MODEL **6 1 / 2 6 6**

NEW STOP SWITCH

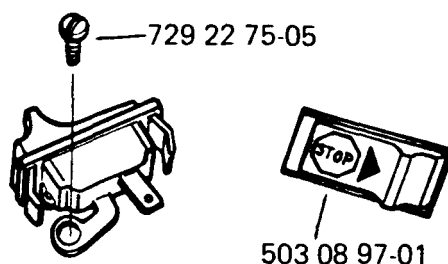
The new stop switch is secured in the crankcase. The width of the terminal on the switch is now 4.8 mm. The previous one was 6.3 mm. Because of this, the ignition module changes its Ref. No. The heat switch is now grounded with round cable clip and changes its Ref. No., too.

The new stop switch can be mounted on older saws if the terminals on the leads are changed and a hole \varnothing 3.0 mm is drilled in the crankcase. Use the switch as a template. For mounting of new switch there is a rebuilding kit available, which contains:

<u>New Ref. No.</u>	<u>Description</u>	<u>Excluded Ref. No.</u>
503 08 97-01	Stop switch	501 81 52-01 (is excluded as a spare part)
729 22 75-05	Screw	—
501 51 61-02	Electronic module	501 51 61-01
501 52 66-02	Heat switch	501 52 66-01 (is excluded as a spare part)

Stop switch 503 08 97-01, terminals,
screws and washers.

The Ref. No. of the kit is 503 48 71-01.
